# MASTERPLAN MASSING, SCALE & LAYOUT

## MASTERPLAN EVOLUTION - FEB 2022

### PRE APP RESPONSE - 23<sup>RD</sup> NOVEMBER 2021

### LVIA WORKSHOP RESPONSE - 11<sup>TH</sup> FEBRUARY 2022

### FEBRUARY 2022 MASTERPLAN

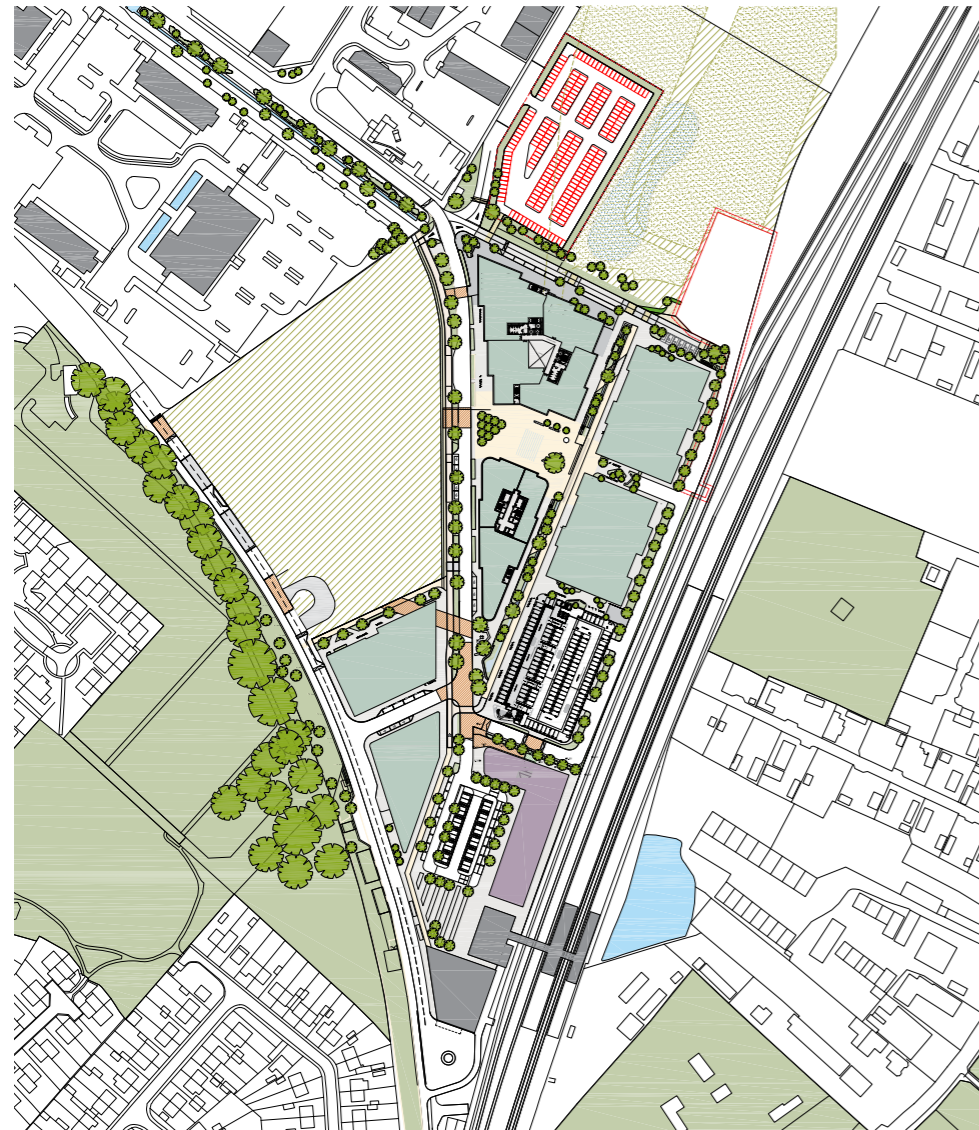
(+) The proposed uses would accord with policy however the lack of residential development does have implications.

(+) Thank you for sending through the notes yesterday from your meeting with officers in the Transport Assessment team at County (...) I have asked to meet with county officers (...) after which I can provide you with an update.

(-) Imperative that provision is made for such modes of transport (e-bikes and e-scooters).

(-) The loss of the residential element at this time raises some concerns (...) you have provided class E uses at ground floor levels. Without the residential element (...) we now need to understand the implications for the proposal.

(-) Will there be sufficient demand for these spaces to become occupied as envisaged.

(-) Will the success of the businesses in the area undermine what could be delivered in the rest of the AAP area.

(-) The previous iteration of the scheme had a strong synergy between the development on either side on Milton Avenue and between One Milton Avenue and adjoining residential development. (...) Without the residential scheme being included there is potential that some key drivers and synergies will be lost.

(-) There are no direct issues with the proposed realignment of Swale street but there are some concerns with its relationship with Cowley road where pinch points are created.

(-) It may be better to rotate Cowley road to align with these field boundaries (...) further consideration required.

(-) The increase in cycle path width has reduced the width of one of the pavements and we cannot understand why this has occurred.

- All buildings on eastern edge moved west to allow for mature tree lined planting along the road.
- All buildings on eastern edge moved north allowing for increased width of pedestrian pavement in between the hotel and the Mobility Hub.
- Triangle site reconfigured to accommodate eastern edge movements.
- S9 reconfigured to allow for more stepping and articulation.
- Swale street shifted west in line with movements.
- Mobility Hub reduced in height by one storey.

(+) Principle has been adopted and retained in latest masterplan proposal.

(+) Pending planners coordination with transport assessment team at County.

(+) Mobility hub strategy for future adaptive reuse for alternative modes of transport/ use presented.

(+) Swale street, S7 and S9 reconfigured to remove pinch points.

### FEBRUARY 2022 MASTERPLAN

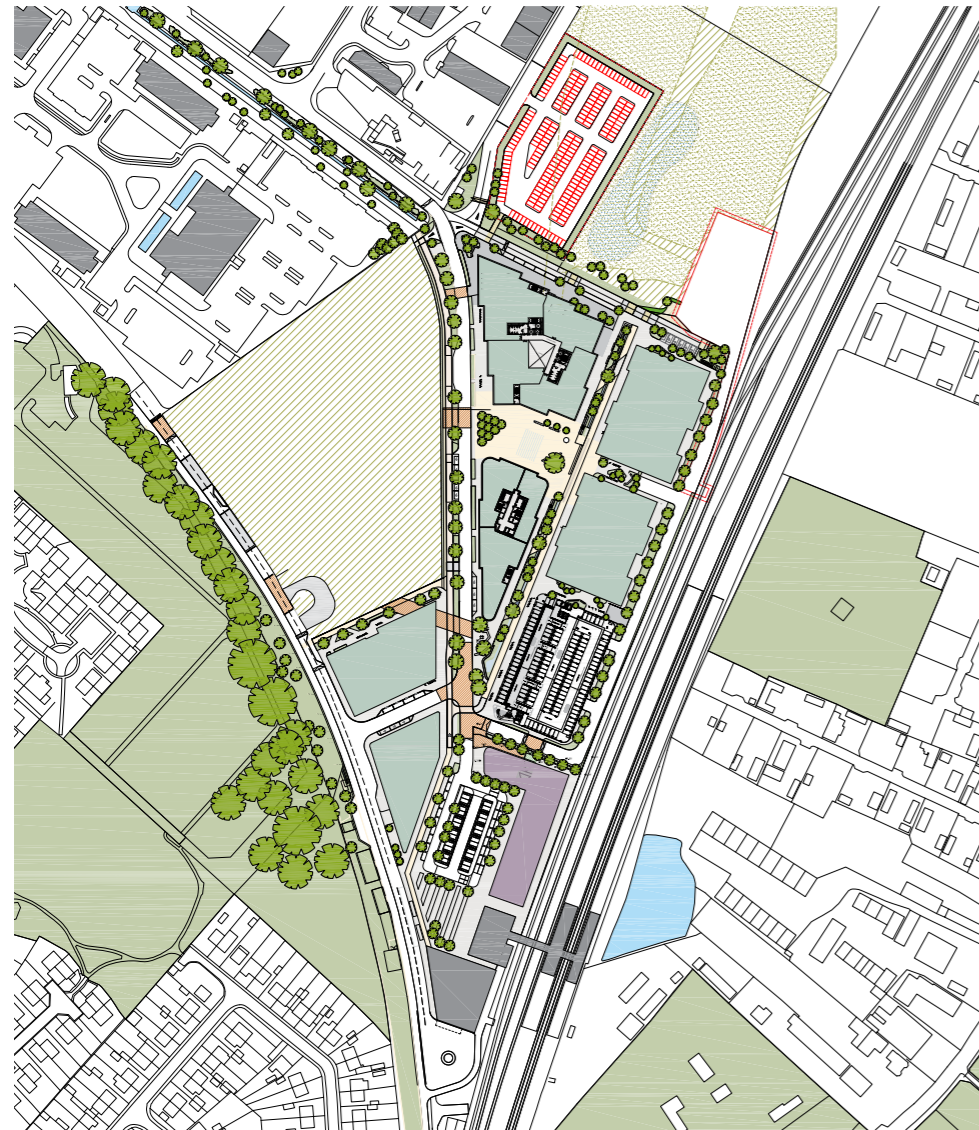
- (-) Widening the cycle way to 3.5m would help to future proof this important route.
- (-) Introduction of disabled parking is supported however further information on the treatment of these spaces (...) is required

- (-) Cycle parking in stores on the side street is not supported
- (-) Reduction of commercial/active frontage on Swale street is not supported.

- (-) Suggested increased height to provide PVs or a sedum roof is disappointing (...) suggest you consider reducing the height of the building (...)
- (-) Previous iterations of the building showed how the internal section could be removed to provide residential (...) why has future proofing approach not carried forward.
- (-) The external appearance of the building seems to have taken a step in the wrong direction.
- (-) Planters will require specialist care including irrigation and replanting/thinning/densifying on a regular basis. Who will this be managed by?

- (-) Further changes have been made to the elevation design, but there was limited opportunity to consider the changes in any detail. Can elevation drawings be provided. (...) View from the residential development has been one of the most critical, but not presented.
- (-) Removal of residential element from proposals jeopardises connections.
- (-) To create a clear and welcoming cut-through to the potential residential development therefore we suggest you revert to the previous iteration.

- (+) The massing and articulation work well from street level, particularly with the part overhand on the street above entrances.
- (-) The scheme would benefit from further thoughts on changes in materiality and elevational modelling to create an impression of series of buildings on a street.

(+) Road north of S9 moved to align with Cowley Road.

(+) Cycle path on Swale street reverted to 3m width.

(+) Cycle way widened to 3.5m.

(+) Blue badge parking has been provided following standards for all buildings within scheme.

(+) Cycle parking stores have been move within buildings, opening up spaces for landscaping / public realm space.

(+) Retail units lost on western edge of mobility hub restored to previous iteration.

(+) Basement added, to reduce building height be a full storey.

(+) Additional studies shown on future-proofing of the Mobility Hub as a cycle storage hub undertaken.

(+) Revised approach to facade utilising folded metal panels to create depth and to break down the building massing has been adopted.

(+) Further elaboration on plant and planter types, maintenance strategy and management duties presented.

### FEBRUARY 2022 MASTERPLAN

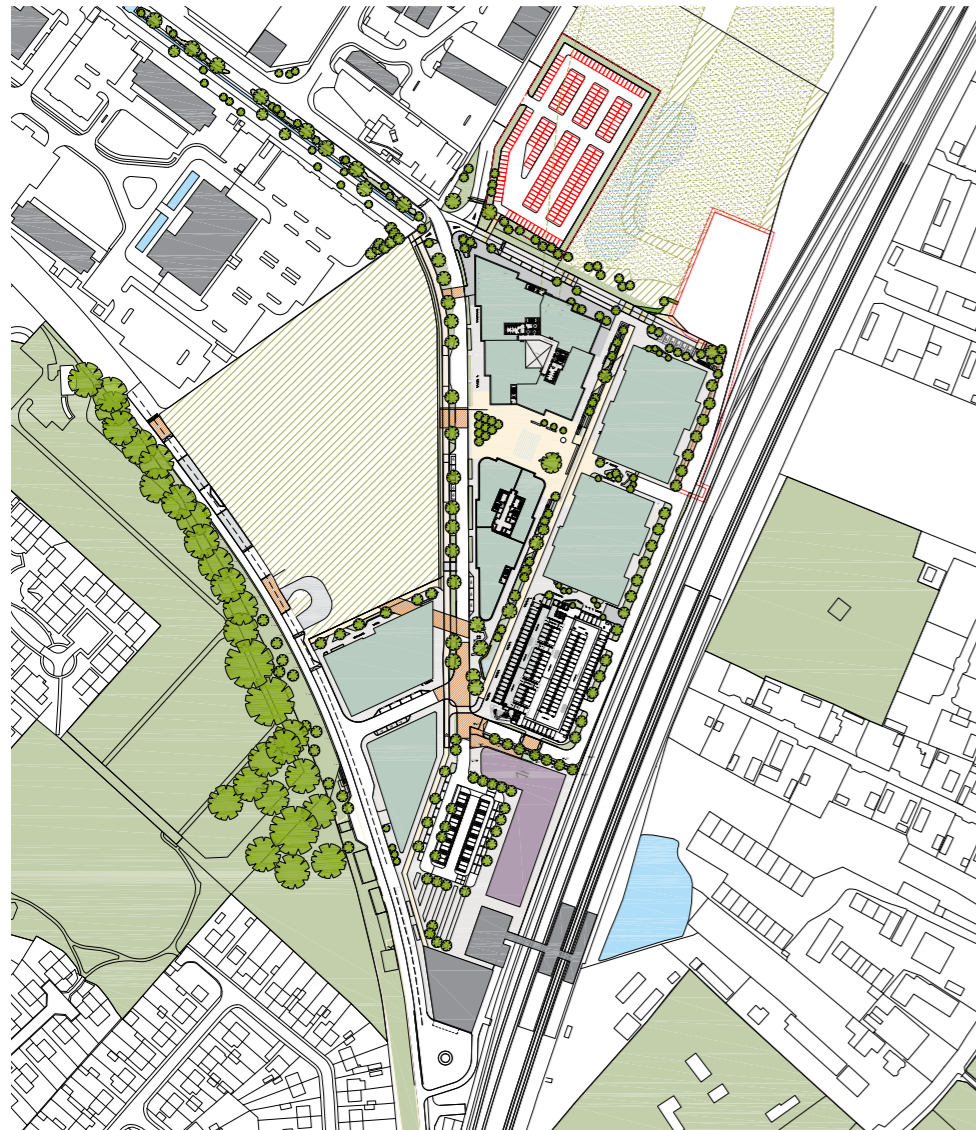
- (-) Further information needed on detailing.
- (-) Solutions for providing landscape softening against the railway edge of the lab buildings is required.

- (-) Further consideration is required here. Whilst the loss of the tertiary street is understood from a commercial perspective there is a concern that grain of the development is getting coarser.
- (-) Further discussion on scale and massing of these buildings and how they will impact the long views of the site.

- (-) Thought needs to be given as to how to make this open space successful in terms of usable open space provision for occupants of the buildings.
- (-) Suggest that you take the opportunity to develop a well-designed, usable and ecologically diverse space.
- (-) Any public paths should be designed with full accessibility in mind.

(+) Previous column free iteration adopted.

(+) Principle has been adopted and retained in the latest masterplan proposal.

- (+) Further workshops conducted showcasing building in further detail
- (+) A series of trees have been introduced along the eastern edge to soften up the edge in between the lab buildings and the train tracks.
- (+) S9 has been reconfigured further to articulate and break down building massing across various elevations.
- (+) Initial conceptual study on facade treatment undertaken to express how facades can mitigate long views on site.
- (+) Wild habitat has been developed to provide varied uses to future occupants of the masterplan.

24.11.2021 View 8

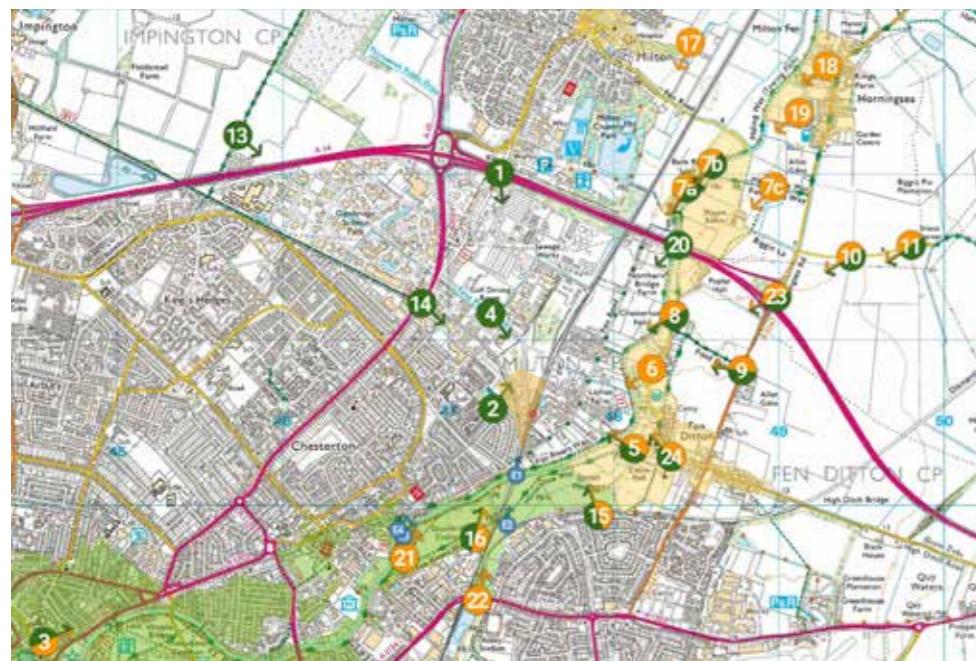
(-) Latest elevation drawings show a large relatively monotonous edge with buildings of very similar heights, pushed up hard against the site boundary, with little in the way of significant landscaping or tree planting to layer and soften its impact. This creates an abrupt hard edge which is not supported.

(-) The draft NEC LVIA has concluded that the eastern edge of the wider site as well as this block is a sensitive edge(...) it is considered that the proposals have not acceptably designed the eastern edge to achieve the recommended 12m height for this edge.

(-) When viewed from a distance(...) the overarching impression is that of a solid wall of development creating an abrupt edge to the landscape.

(-) Lack of vegetative buffering along the eastern boundary, as well as the mass and heights along this boundary are unacceptable.

(-) Ultimately what is needed is for the buildings to move back to allow for significant tree planting and to be reduced in height to the rail station.

These studies helped refine the articulation, massing and overall landscaping strategies that were implemented across the wider scheme. As can be observed across the evolution of view 8, one of particular sensitivity, revisions have taken place reducing heights, shifting buildings and adopting greenery to help the Masterplan sit within its context more appropriately.
